Subject: Petition to Amend the Natural Gas Line Route for the Lodi Energy Center Project (08-AFC-10C)

**Petition to Amend
the Natural Gas Line Route
for the
Lodi Energy Center Project
(08-AFC-10C)**

Submitted to the
California Energy Commission

SEC 30	T. 3 N.	R. 6 E.
COUNTY :	SAN JOAQUIN	
DIVISION :	SACRAMENTO	
AUTH # :	30698447	
SHEET NO.	1	SHEETS 2
SG - 088		REV. 2

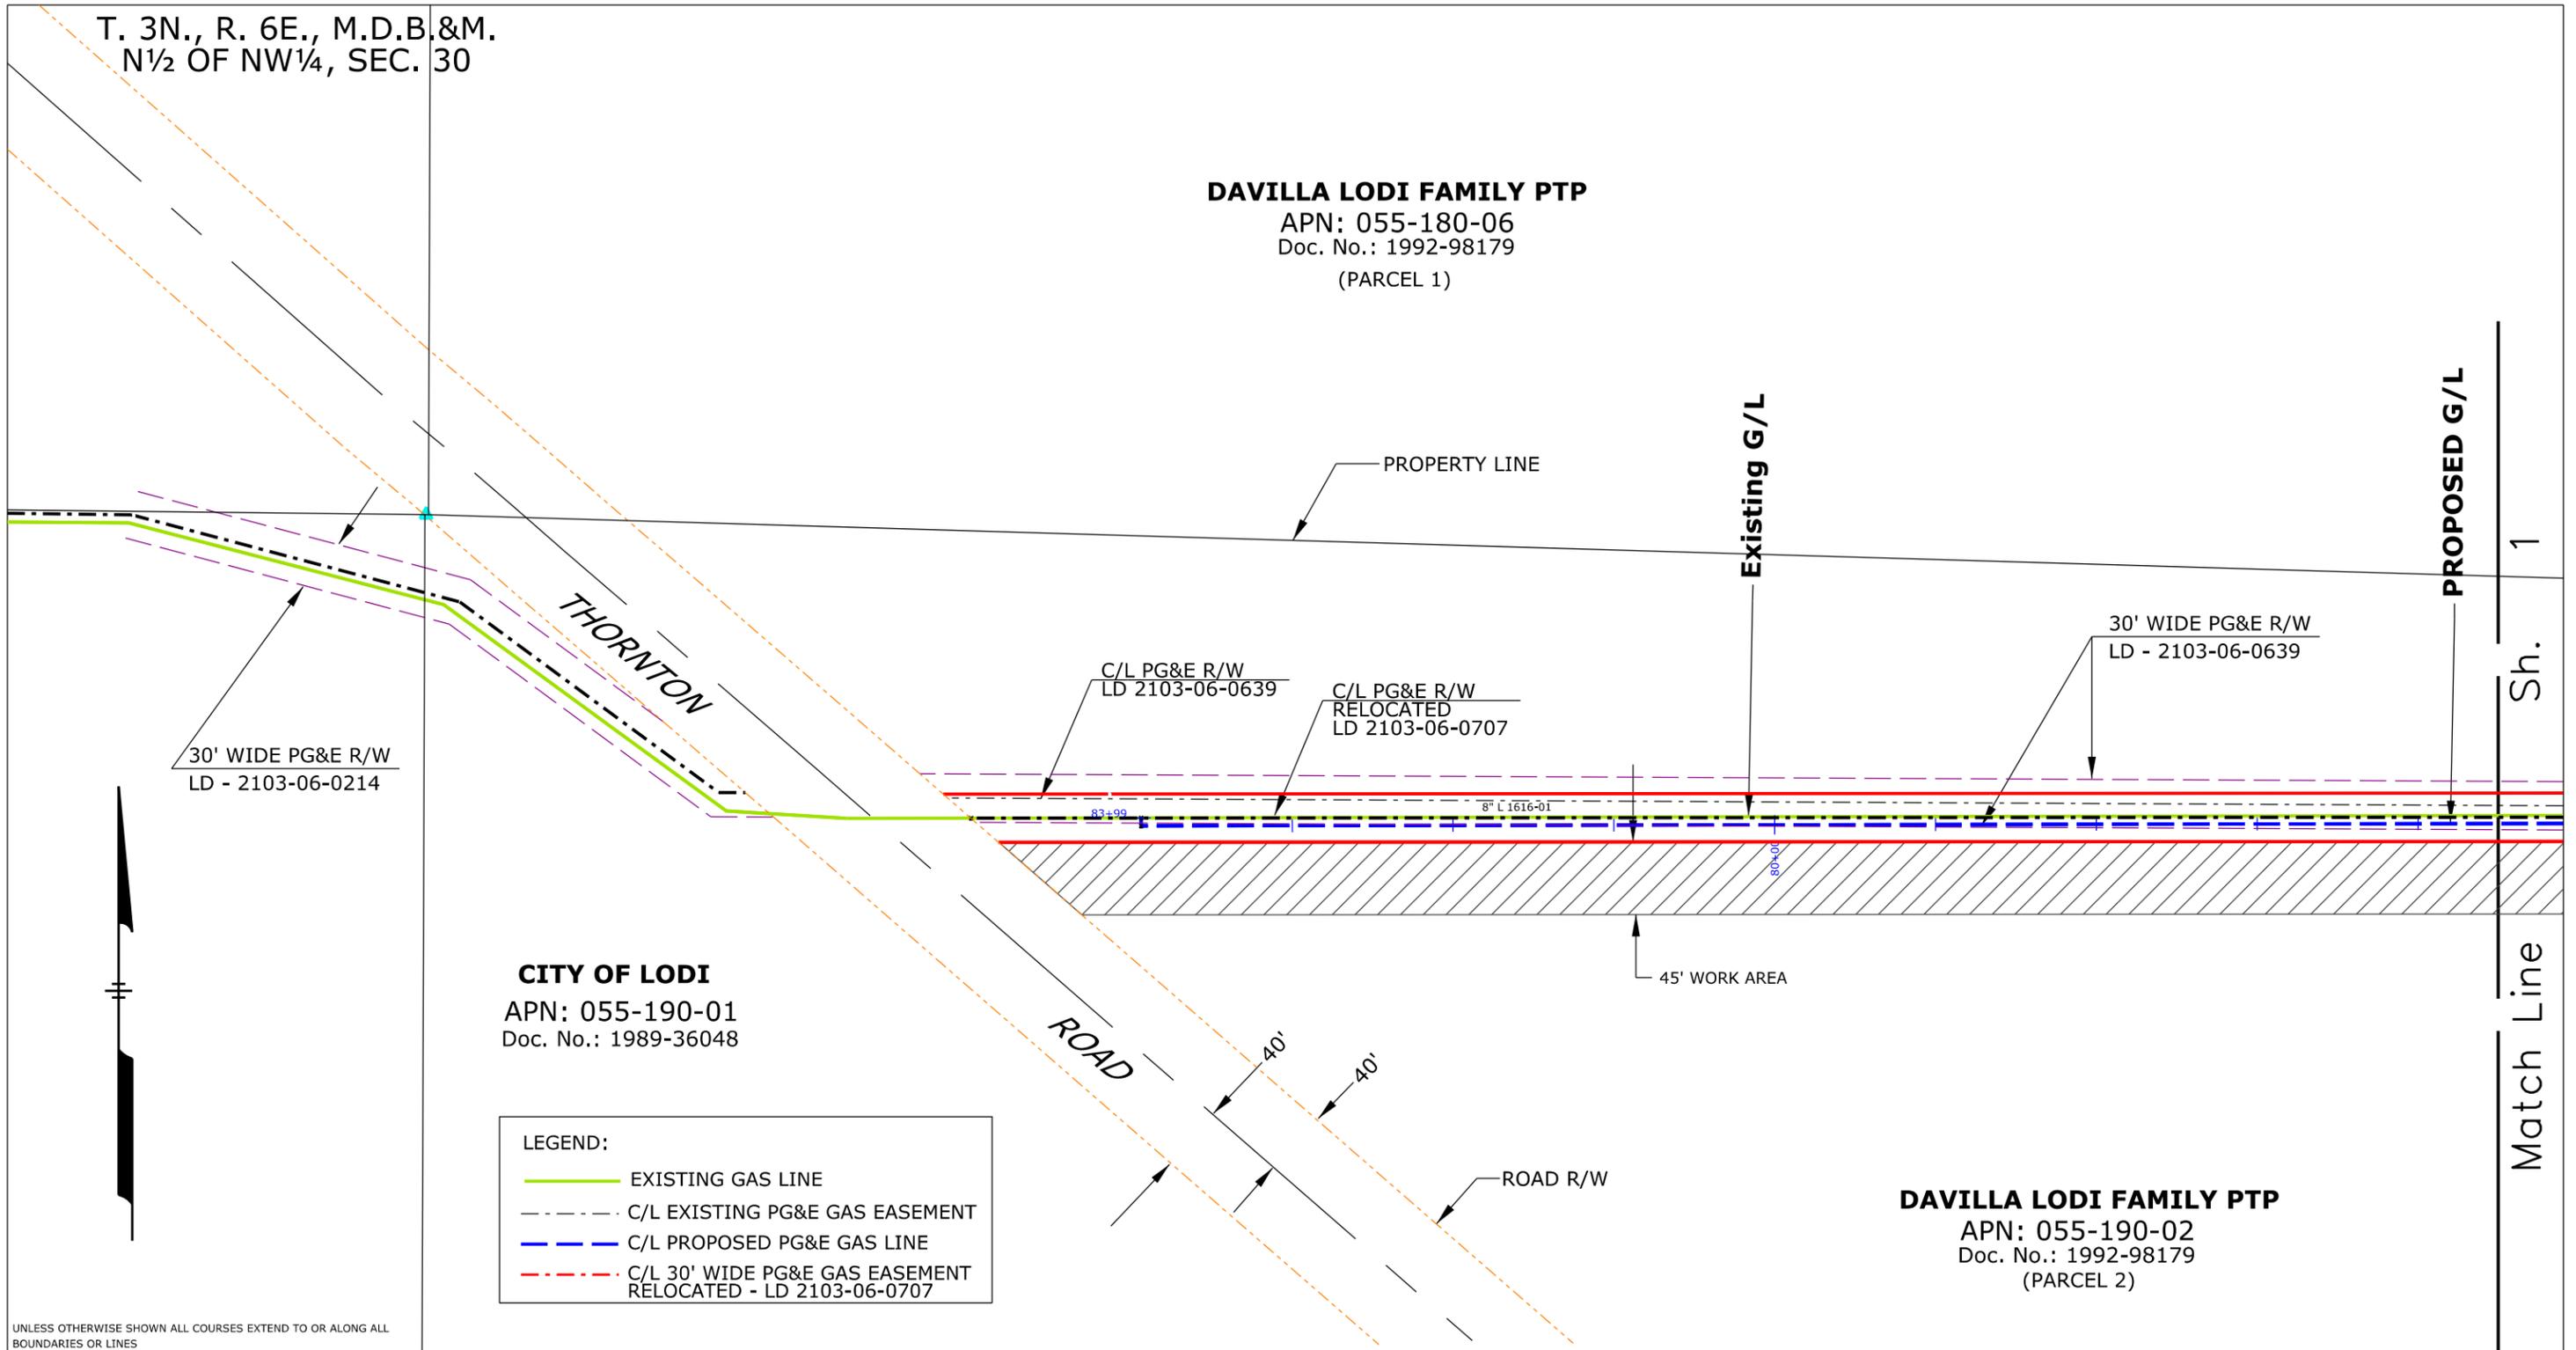
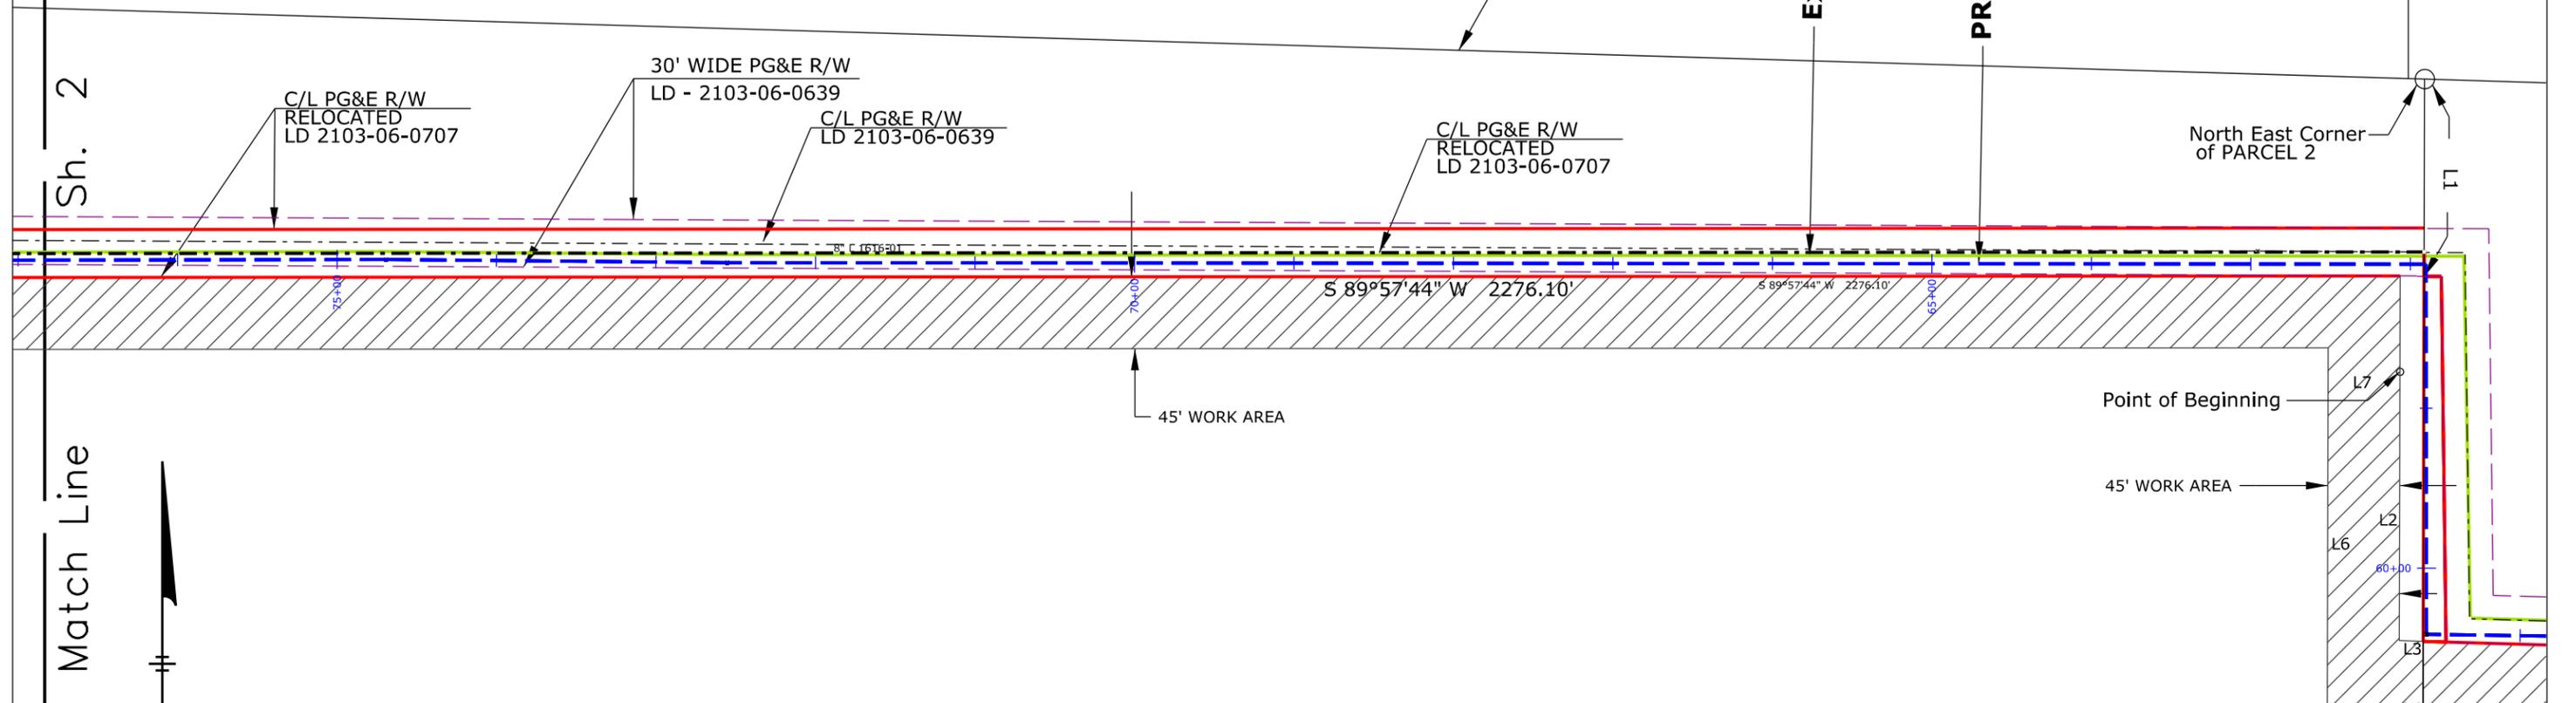
The CEC Final Decision approved a construction easement width of approximately 35 feet for the natural gas line. For those portions of the revised gas line within agricultural fields (approximately 5,090 feet of the total length), PG&E has requested that the construction easement be increased to 75-feet (45 foot construction easement plus a 30 foot permanent easement), resulting in an overall disturbance of approximately 8.92 acres² during construction. The additional width is needed to provide space for pipe, soil piles, and construction vehicle movement. Construction drawings are provided as Appendix A.

NO.	DATE	DESCRIPTION	SEARCH	SEC	COMPS.	SEC	F. B.	SEC
1	7/11	Added work areas						
REVISIONS

SEC 30	T. 3 N.	R. 6 E.
COUNTY :	SAN JOAQUIN	
DIVISION :	SACRAMENTO	
AUTH # :	30698447	
SHEET NO. 1	SHEETS 2	REV. 2
SG - 087

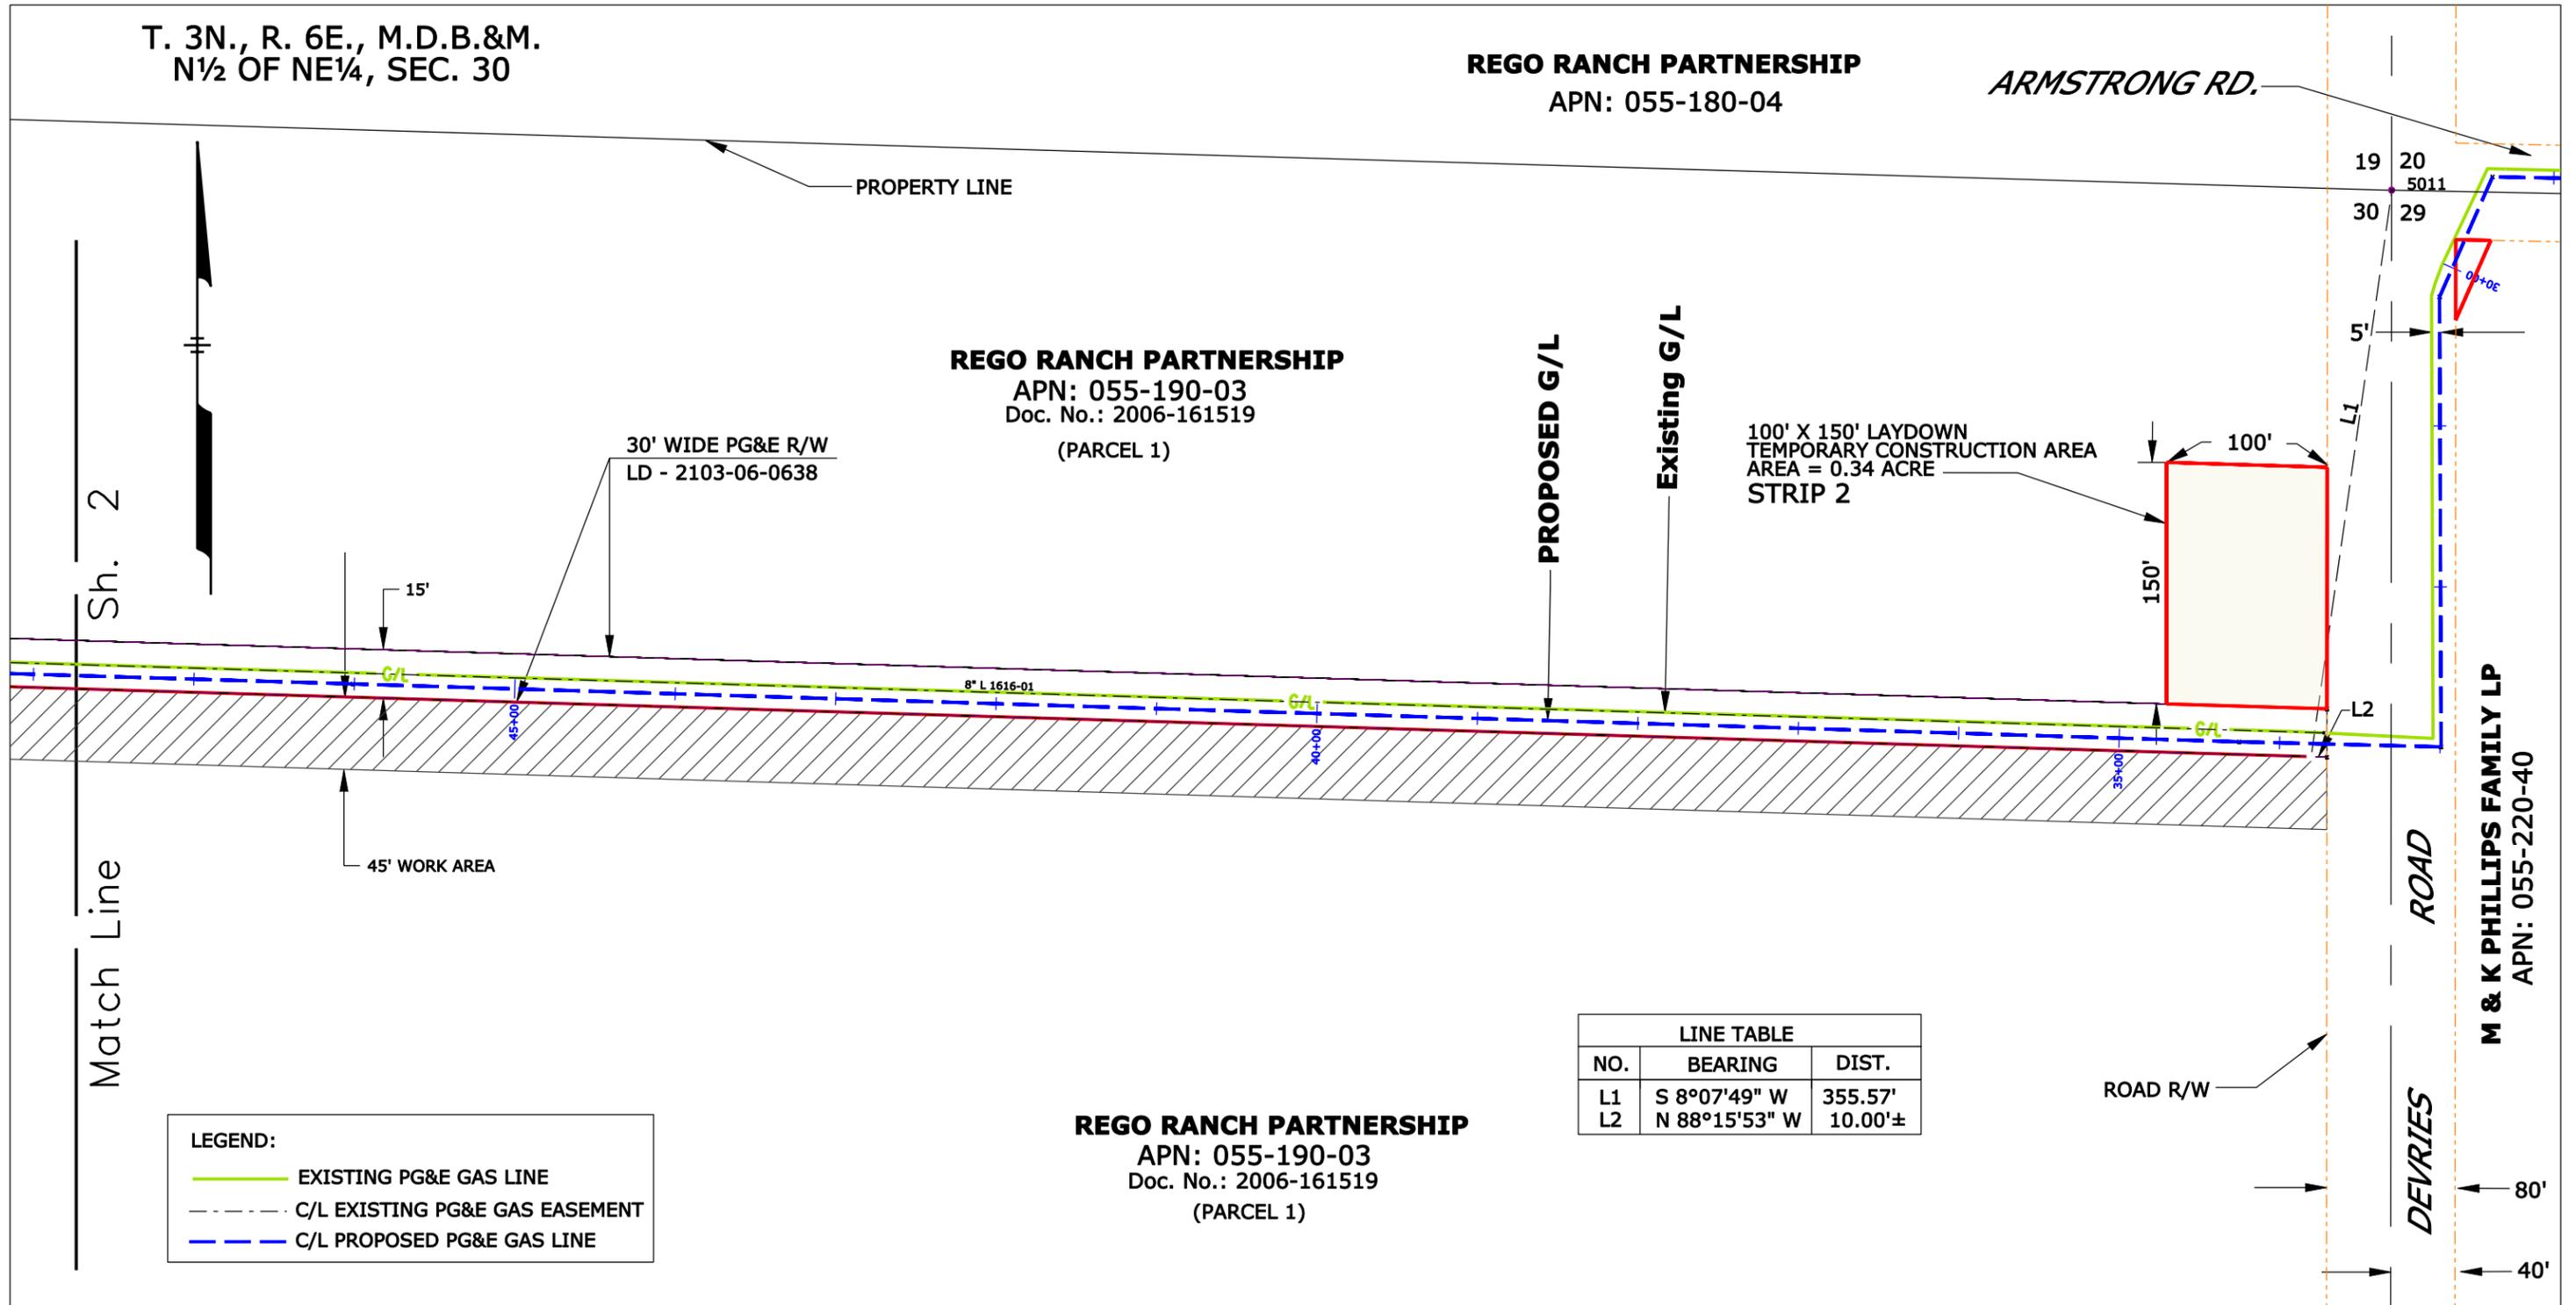
100' X 150' LAYDOWN
TEMPORARY CONSTRUCTION AREA
AREA = 0.34 ACRE
STRIP 2

NO.	DATE	DESCRIPTION	SEARCH	SEC	COMPS.	SEC	F. B.	SEC
1	7/11	Added work areas

Photo of approximate construction easement through agricultural field just east of North Thornton Road, 3/20/11

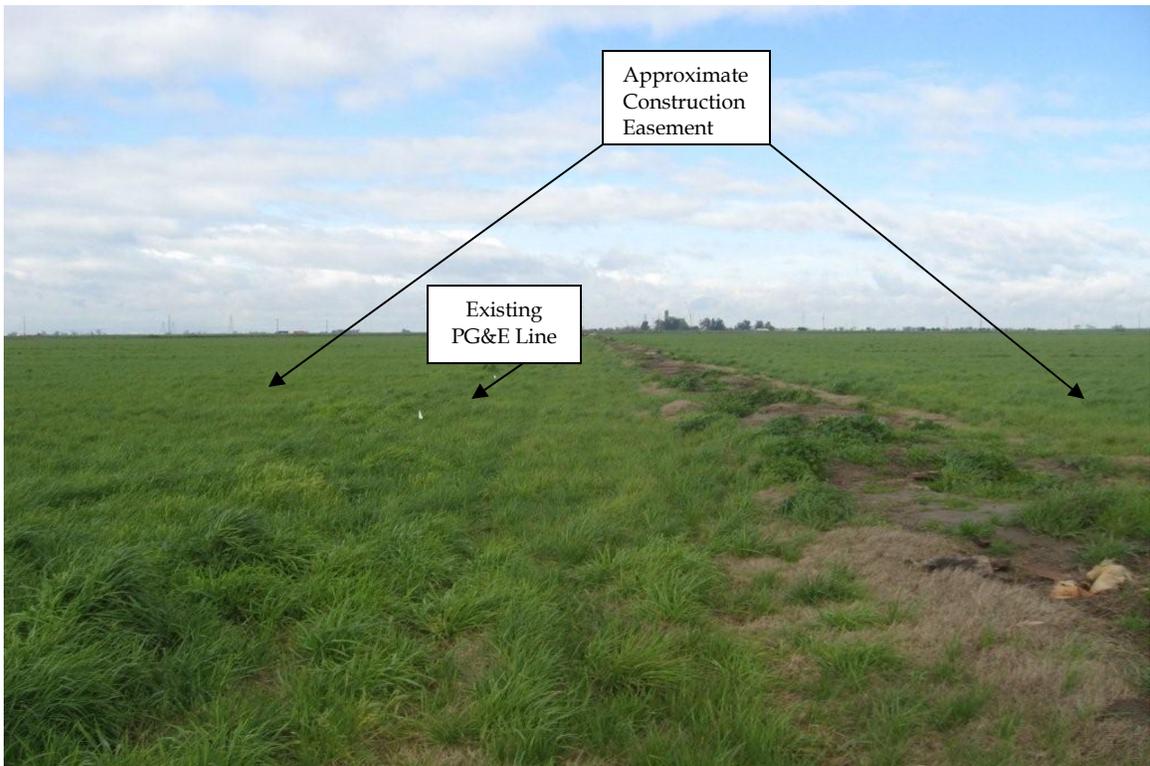
Project design changes from PG&E have moved approximately 2,471 feet of the natural gas line route, shortened the overall length of the gas line route, moved the temporary gas pipe construction laydown area, and increased the width of the construction easement through agricultural land.
